Subject: Duke Energy Carolinas, LLC
William States Lee III Nuclear Station - Docket Nos. 52-018 and 52-019
AP1000 Combined License Application for the William States Lee III Nuclear
Station Units 1 and 2
Response to Request for Additional Information Letter No. 120 (eRAI 7570)
Ltr#: WLG2014.08-01

Reference: Letter from Brian Hughes (NRC) to Robert Kitchen (Duke Energy), Request
for Additional Information Letter No. 120, Related to SRP Section 03.07.02 –
Seismic System Analysis for the William States Lee III Units 1 and 2
Combined License Application, dated July 11, 2014 (ML14192B073)

RAI 03.07.02-3 (eRAI 7570)

Reference NRC RAI Number(s): 03.07.02-3 (eRAI 7570)

Figure 03.07.02-5-2 Pipe Stress Time History (Element 117) With and Without Gaps for CSDRS and HRHF Seismic Input – ADS 4th Stage East Compartment Piping System

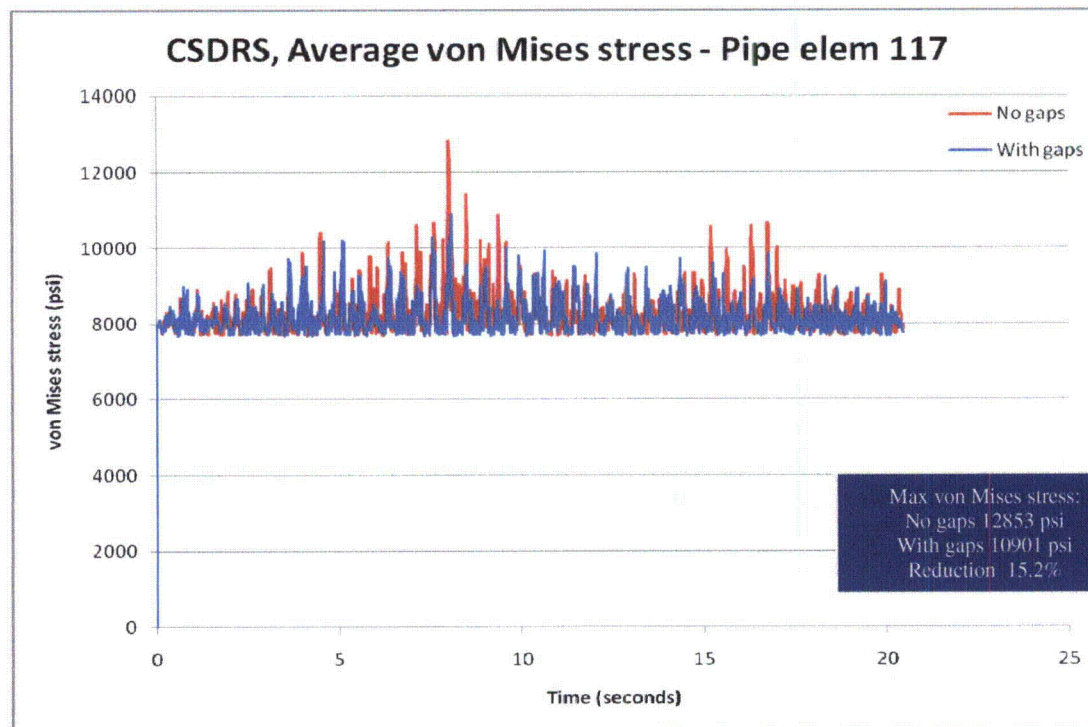
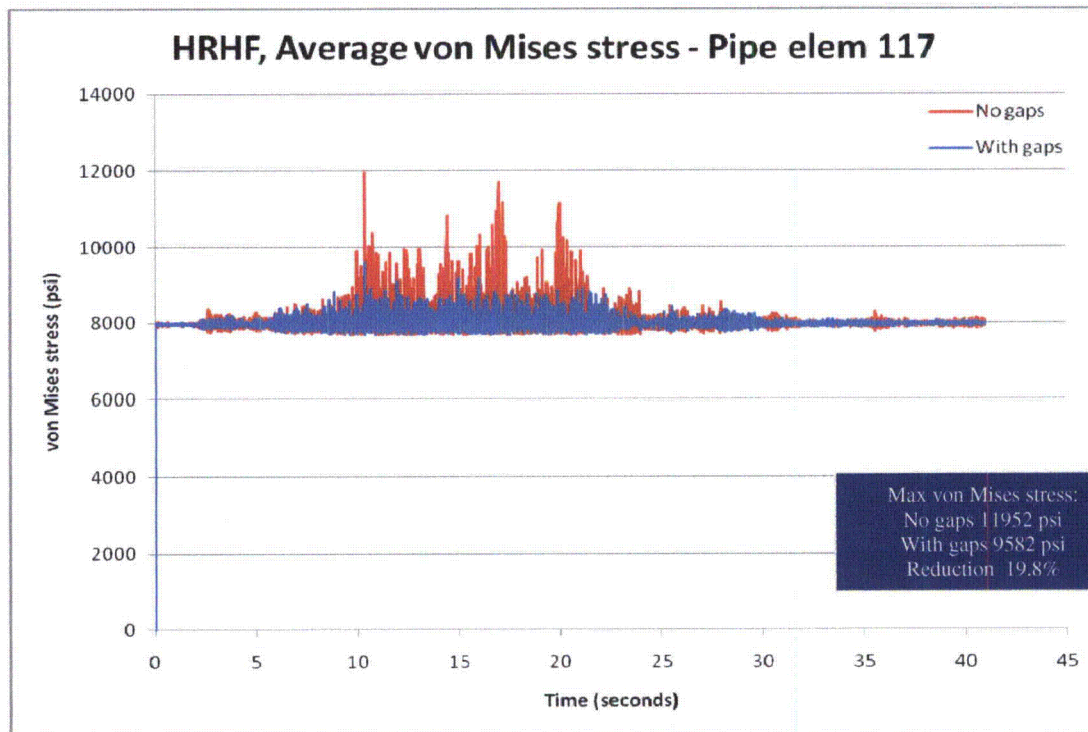
WLS FSAR (Rev. 8) Section 3.7.2.15 states that stresses resulting from site-specific high frequency input are bounded by AP1000 design basis analysis results and the effect of site-specific high frequency input on piping is non-damaging. Further, Section 3.7.2.15 states that although some of the site-specific ISRS exhibit minor exceedances of the comparable standard AP1000 equipment qualification RRS, in all cases the actual TRS used in completed testing exceed the site-specific demands by a significant margin. To assist the staff in its evaluation of the effect of high frequency input to piping and equipment, the applicant is requested to provide a discussion on sources of conservatism in piping analysis and equipment testing. Further, the applicant is requested to provide an estimate of the range of the seismic margin associated with piping analysis and equipment testing.

Further expanding on additional margin associated with the method of analysis of piping systems, including the Duke Lee evaluations discussed above, linear elastic modal response spectra analysis was used for qualification and inherent small gaps in pipe supports were neglected. Examples of these include gaps in pin connections or gaps between the support and the pipe. These two areas of the current piping analysis include inherent sources of margin and conservatism in the analysis of the Duke Lee piping packages. As indicated, a source of conservatism is the use of linear elastic response spectrum analysis. These analyses assume a conservative envelope of FRS, which is applied at multiple support locations throughout a pipe length and many of which actually experience significantly lower loading demands.

In contrast to a response spectrum analysis, time history analyses more accurately represent actual floor response and make use of specific floor acceleration time histories. Further, the linear elastic simulation aspect of such analysis precludes the simulation of actual nonlinear support conditions (e.g. bolted connections with gaps) and results in an over-constraining the piping system.
